**RELEASED FOR  
 FABRICATION / INSTALLATION**  
 PPPL Drafting:

Oak Ridge National Laboratory managed for the DEPARTMENT OF ENERGY under U.S. GOVERNMENT contract DE-AC05-00OR22725 UT-BATTELLE, LLC, Oak Ridge, Tennessee PROJECT NAME						
NATIONAL COMPACT STELLERATOR EXPERIMENT VACUUM VESSEL PERIOD INSPECTION AND LEAK CHECK ASSEMBLY						
VERSION NO.	PLANT	BLDG	FL	SHT OF	TYPE	CLASS
5	X-10	5700	3	2 19	A	U
RELEASE LEVEL		SE120-004			REV	
Fabrication					2

TYPICAL PORT 10A AND 10B  
SECTION PORT10-PORT10

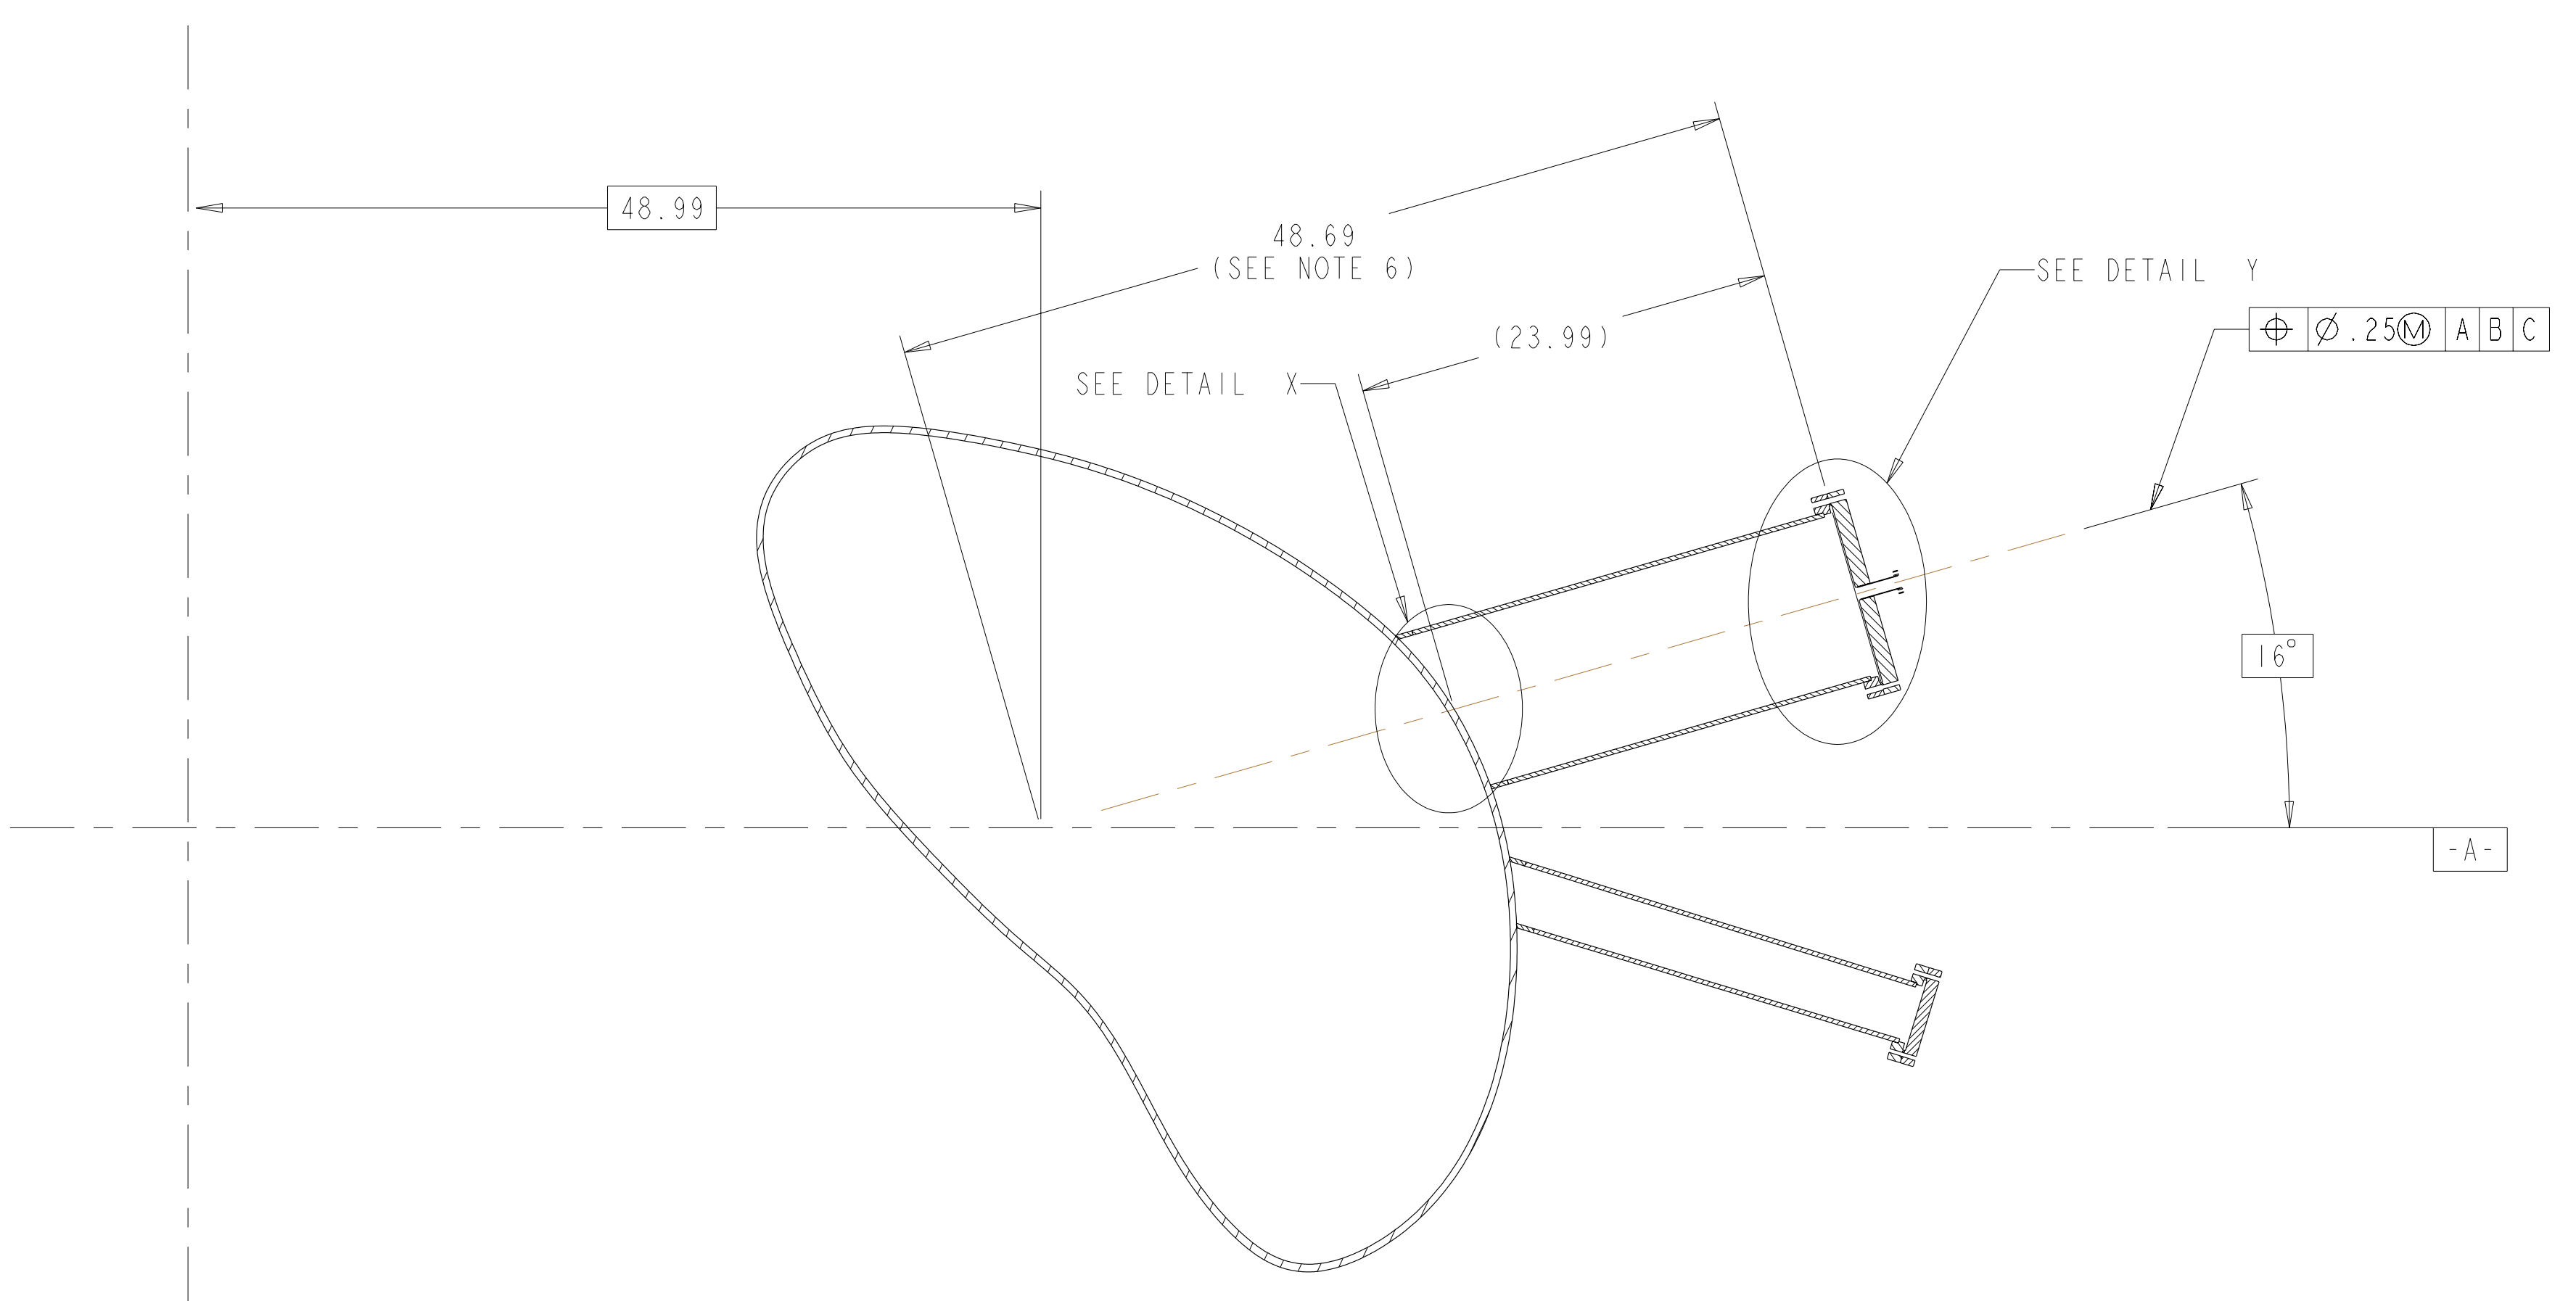
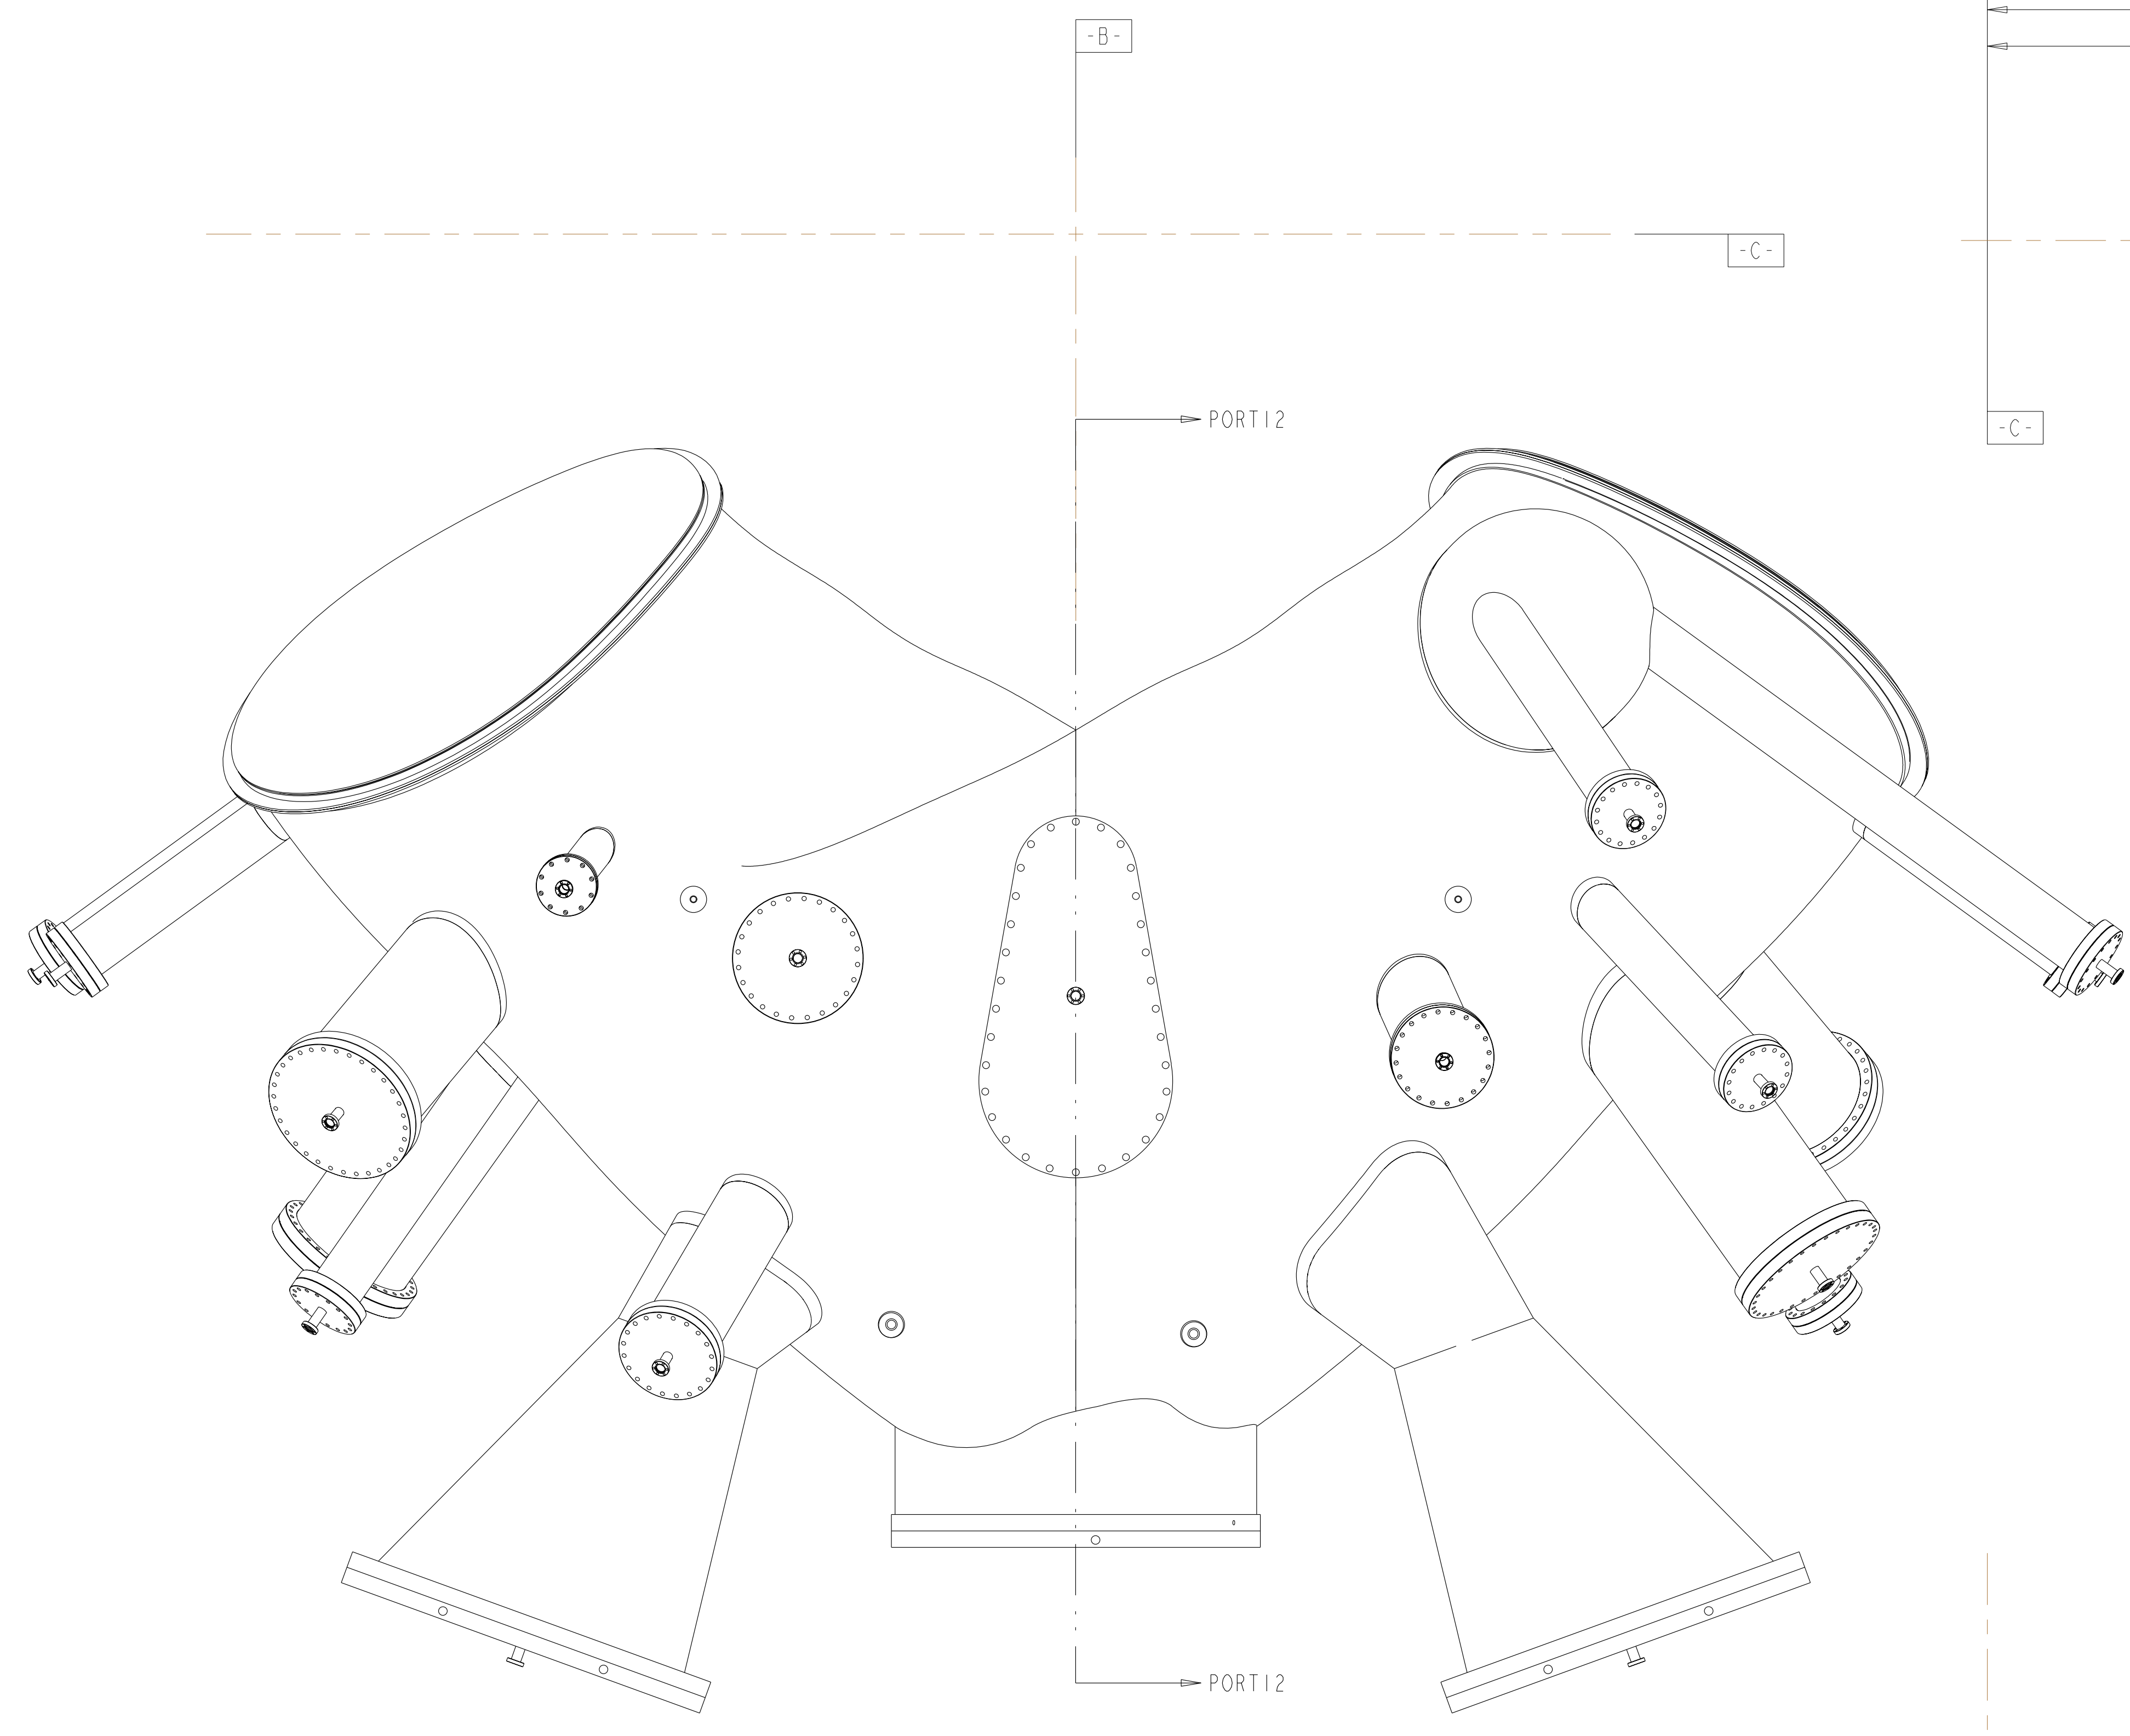
**Rev 2-e: ECN-5021 (RFD-12-017) approved alternate methods for welding the port extensions to the VVSA (See ECN-5021 for details). – Only applicable to VVSA #3 – VVSA #1 and #2 covered by NCR 19464.**

**ECN-5082.** Requirement originally included grooves to facilitate leak checking by vendor. However, vendor elected another means of leak checking and therefore the grooves are no longer required. Specifically, this ECN eliminated the leak checking groove on SE121-014 (Rev 1-c) and SE1221-091 (Rev 0-a). Additionally, this ECN added a missing weld symbol to SE121-004 (Sheets 4 through 19) for joining the port extensions to the vessel (Rev 2-d).  
**(See ECN-5082 for details)**

SECTION PORT12-PORT12

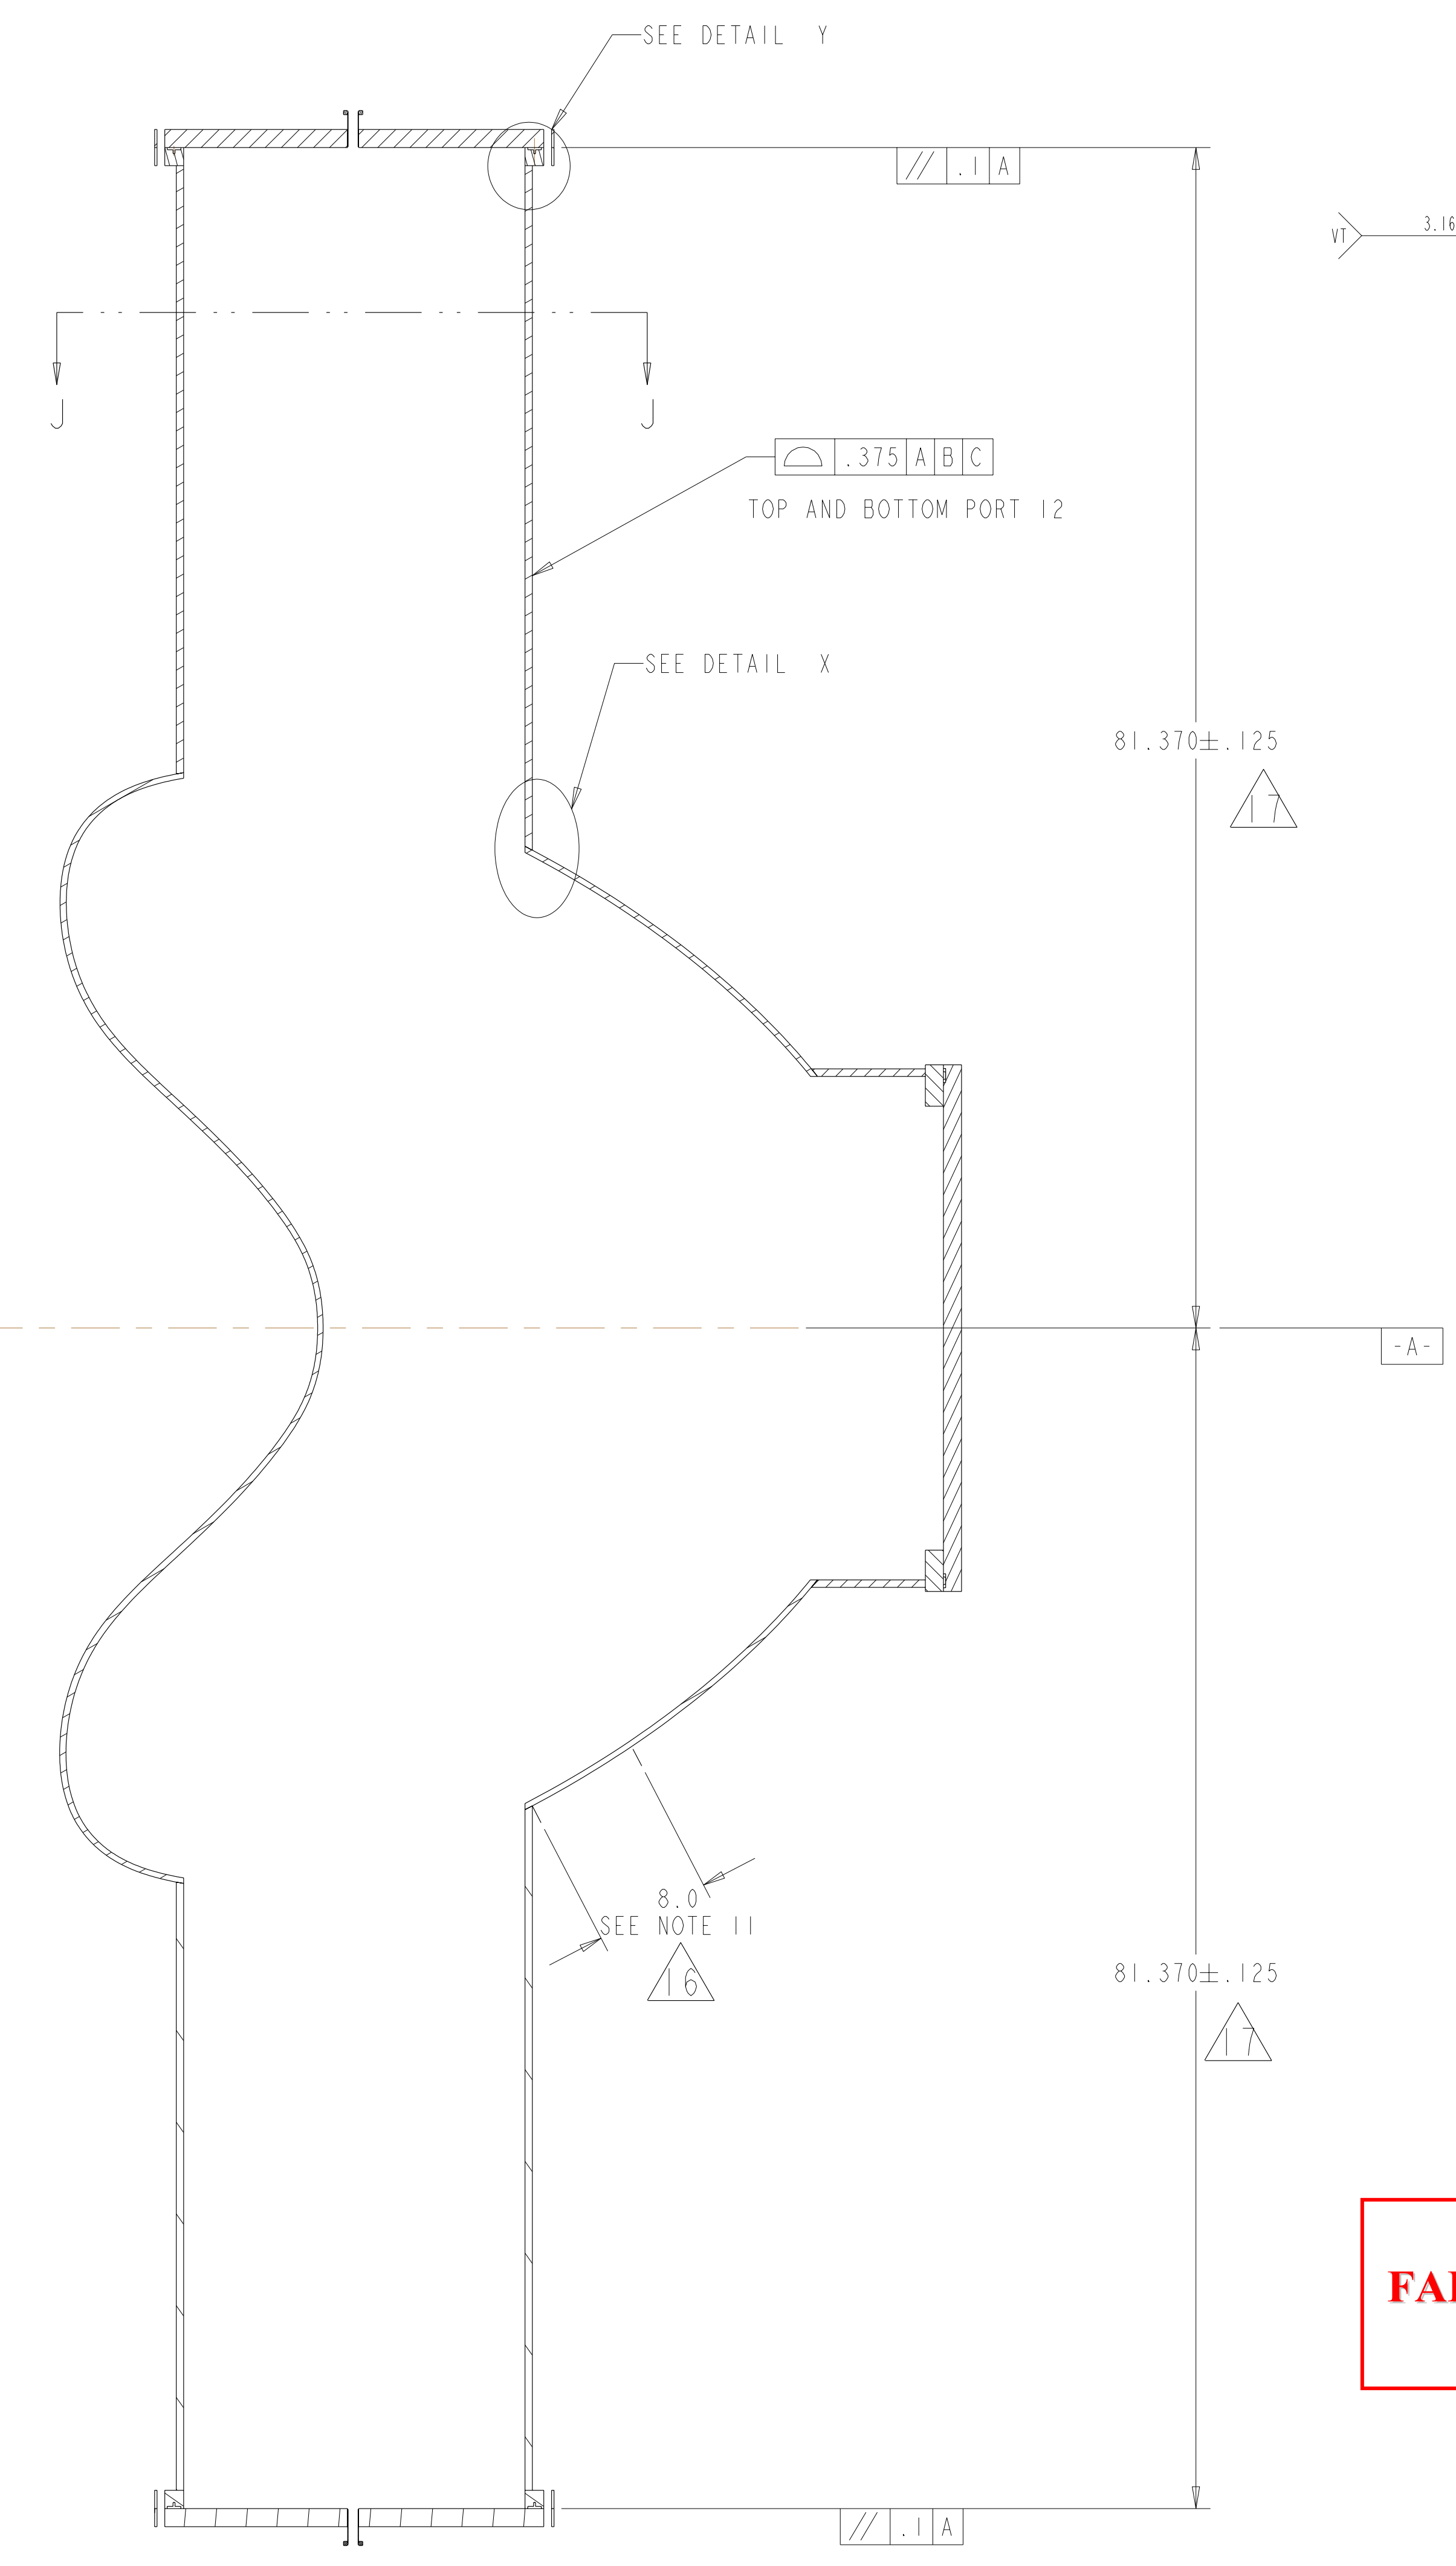
**Rev 2-e: ECN-5021 (RFD-12-017) approved alternate methods for welding the port extensions to the VVSA (See ECN-5021 for details). - Only applicable to VVSA #3 - VVSA #1 and #2 covered by NCR 19464.**

**ECN-5082.** Requirement originally included grooves to facilitate leak checking by vendor. However, vendor elected another means of leak checking and therefore the grooves are no longer required. Specifically, this ECN eliminated the leak checking groove on SE121-014 (Rev 1-c) and SE1221-091 (Rev 0-a). Additionally, this ECN added a missing weld symbol to SE121-004 (Sheets 4 through 19) for joining the port extensions to the vessel (Rev 2-d).  
(See ECN-5082 for details)
